RE: AGRICULTURAL DRAINAGE/MAINTENANCE PLAN,  
BURNABY BUSINESS PARK'S INDUSTRIAL  
DEVELOPMENT PROPOSAL IN THE BIG BEND AREA

TO: MUNICIPAL MANAGER 1990 February 26

FROM: DIRECTOR PLANNING & BUILDING INSPECTION Our File: 02.120.5  
RZ #81/89

SUBJECT: AGRICULTURAL DRAINAGE/MAINTENANCE PLAN,  
BURNABY BUSINESS PARK'S INDUSTRIAL DEVELOPMENT  
PROPOSAL IN THE BIG BEND AREA

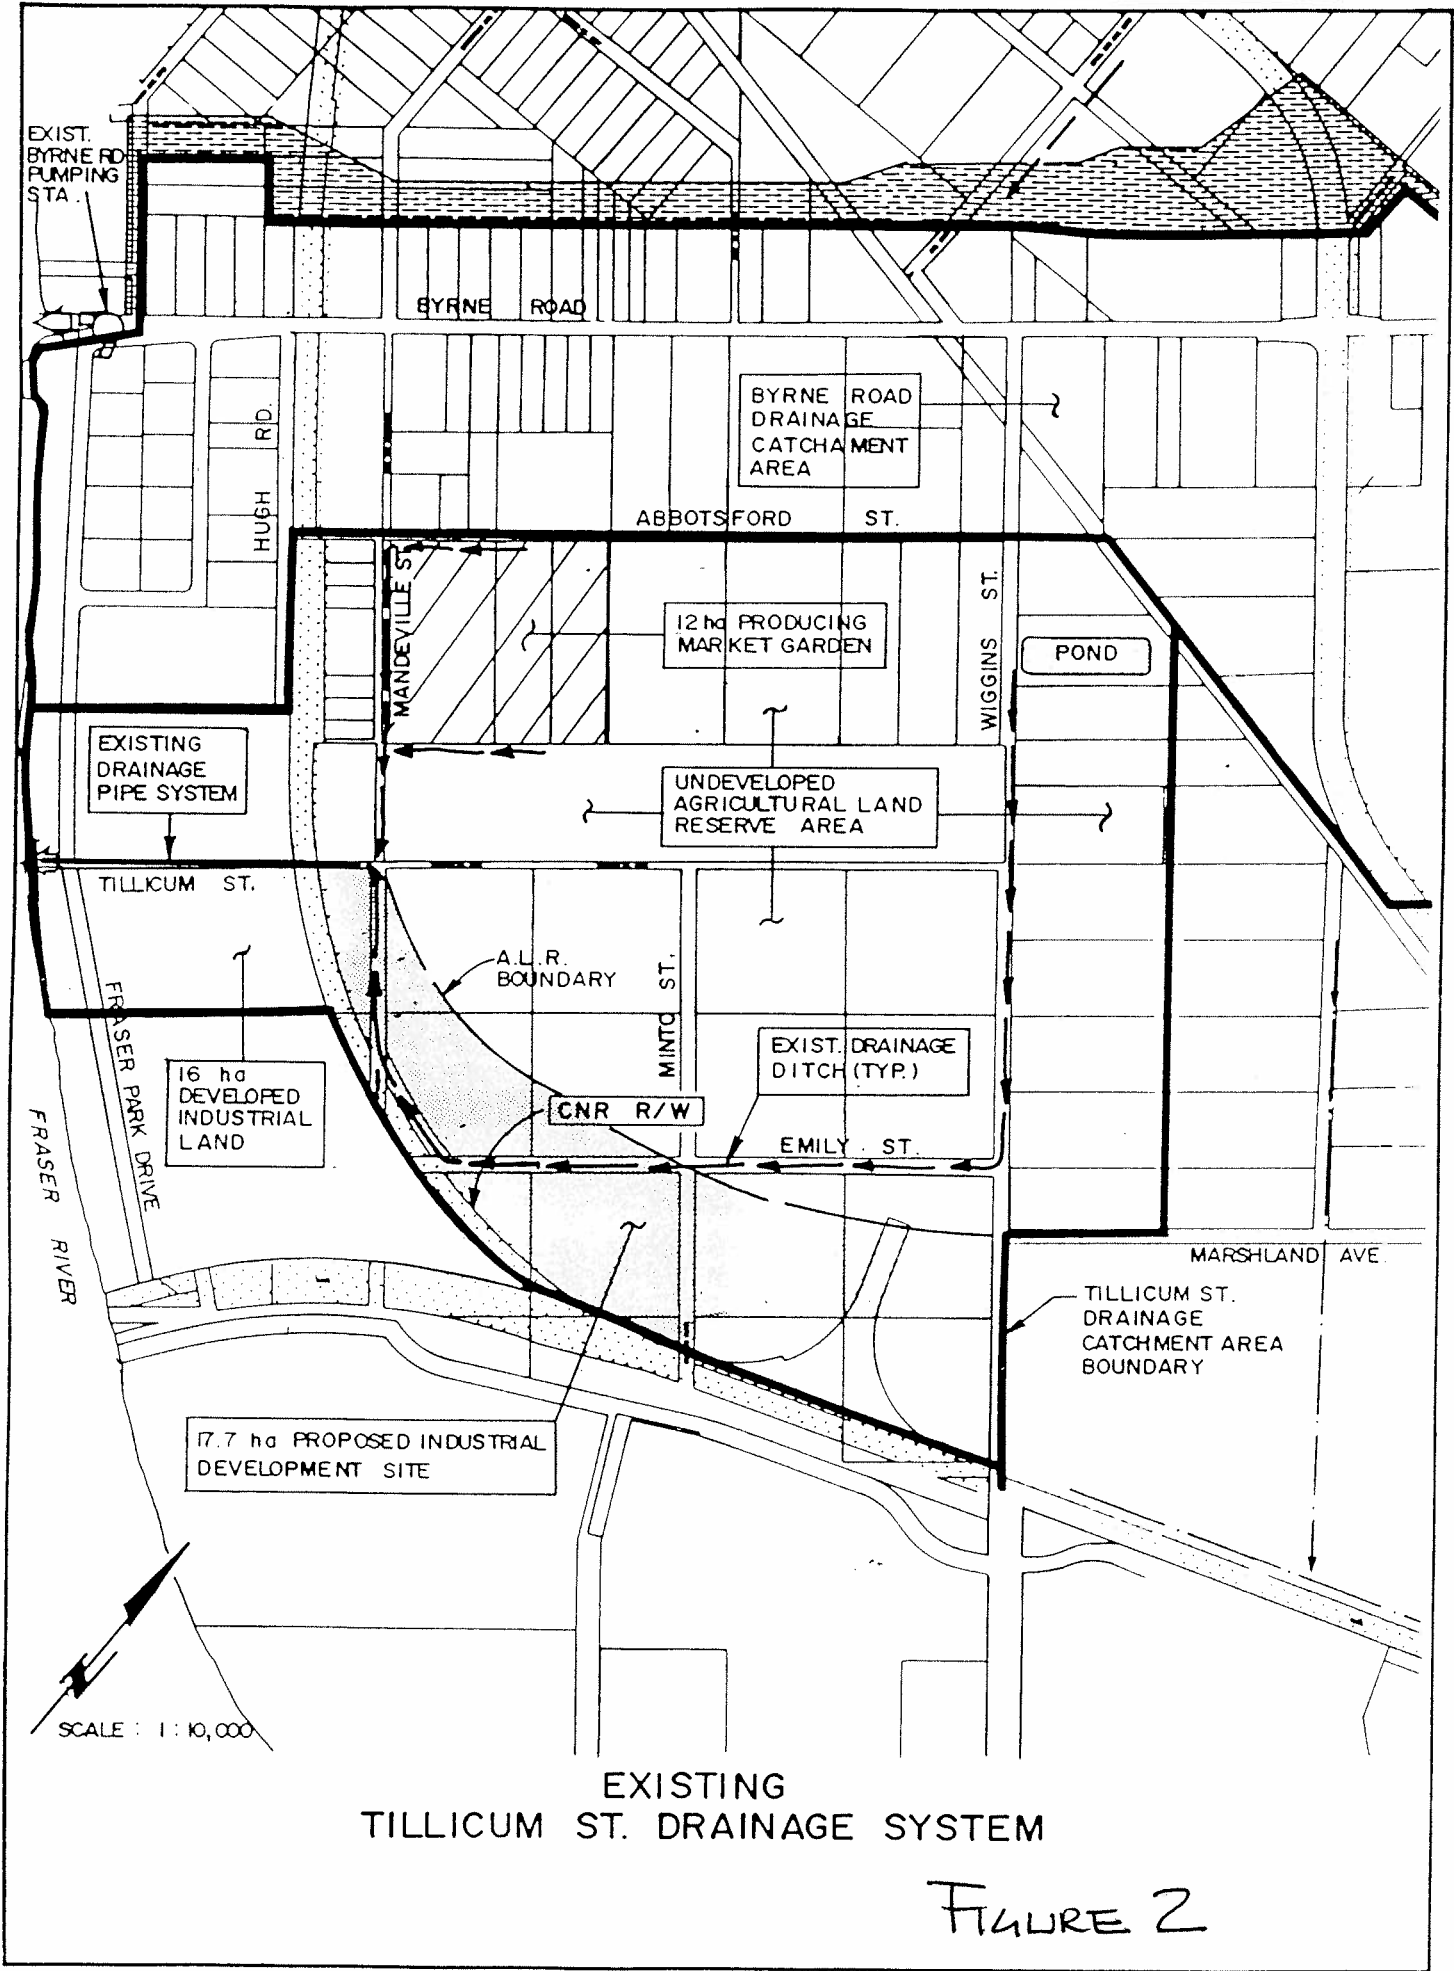
Of particular importance is the impact of fill placement on the existing groundwater and drainage patterns on the agricultural capability of the ALR lands. A major drainage channel presently runs through the site as shown on the attached Figure 2. It was noted that it will be necessary for the developer to prepare a drainage management plan to specifically address the methods by which the groundwater and drainage will be accommodated.

The catchment area of the industrial lands and the majority of the agricultural lands is presently drained by an open ditch system north of Mandeville Avenue connecting to a pipe system on Tillicum Street which in turn discharges to the Fraser River (see Figure 2). The system is affected by the tidal fluctuations of the Fraser River and is interconnected to the Byrne Road drainage system by means of CNR track ditches. The Byrne Road system also discharges to the Fraser River but is supplemented by a pump station during periods of high tides and runoffs.

DRAINAGE IMPROVEMENTS REQUIRED FOR INDUSTRIAL LAND DEVELOPMENT

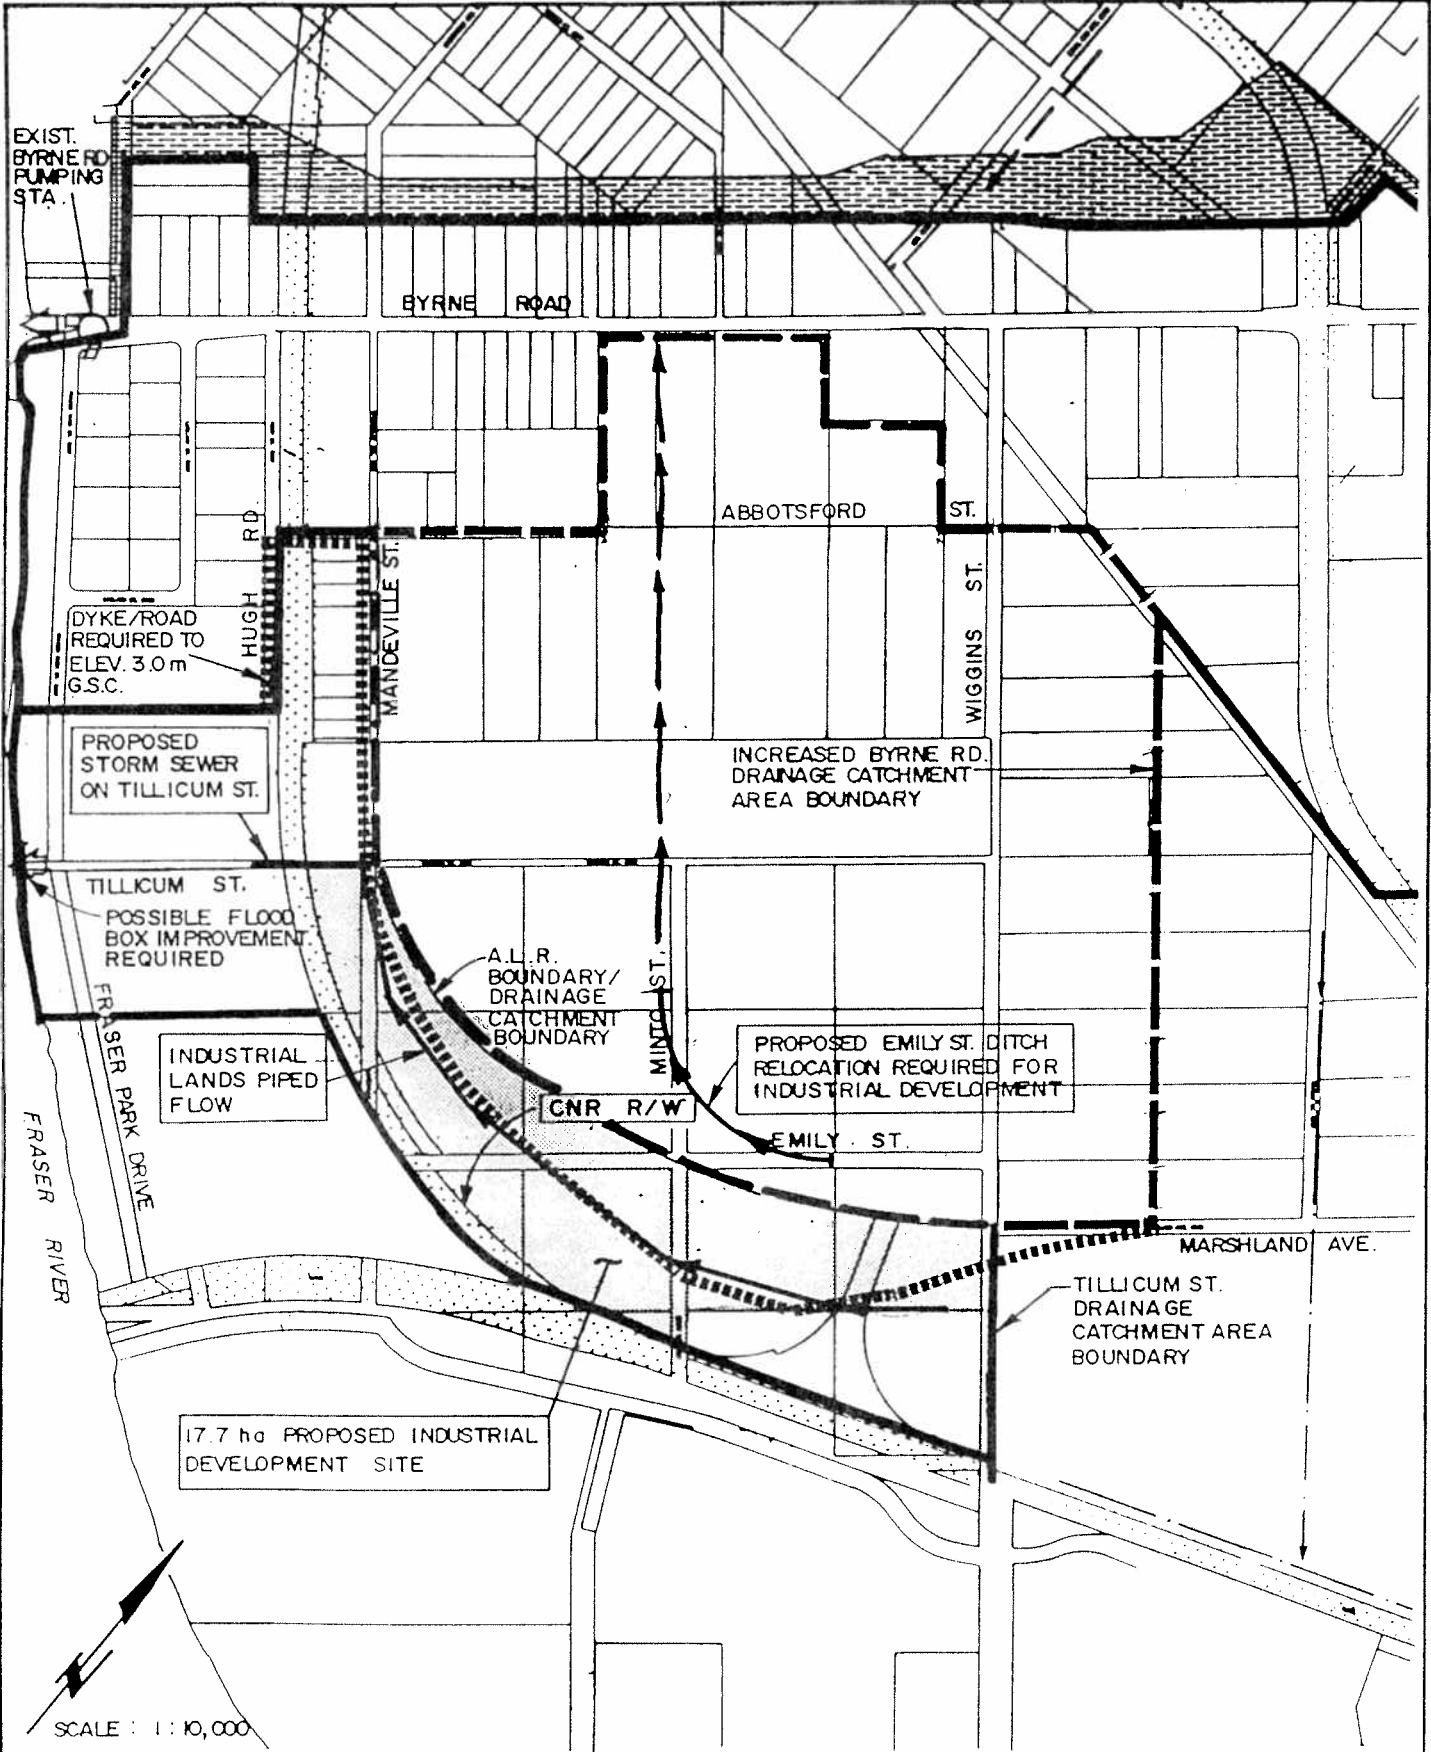
A staff review in conjunction with Mr. Driehuyzen concluded that a central routing was the most advantageous from an agricultural perspective. A central alignment would minimize the length of cross ditches to the main drainage channel and would eliminate the risk of non-intended users discharging to the main drainage channel. This latter feature would be in keeping with the management plan terms of reference requirement of separate industrial and agricultural drainage systems. A ditch rerouting alignment which meets this criteria is shown in Figure 3 attached. The ditch would drain towards Byrne Road, thereby discharging into the Byrne Road drainage system and utilizing the excess capacity of the Byrne Road pumping station. The increased catchment area to the Byrne Road drainage system is shown on Figure 3.

A culvert crossing will be necessary at the proposed ditch intersection with Byrne Road. In the design of this system, staff will require the inclusion of devices to ensure that no backflows will occur from the Byrne Road ditch to the agricultural lands. The relocated ditch will be designed below the elevations necessary to maintain the design flows thereby providing for water for irrigation purposes. The ditch design will require consideration of present drainage patterns within the agricultural lands as well as future drainage patterns.
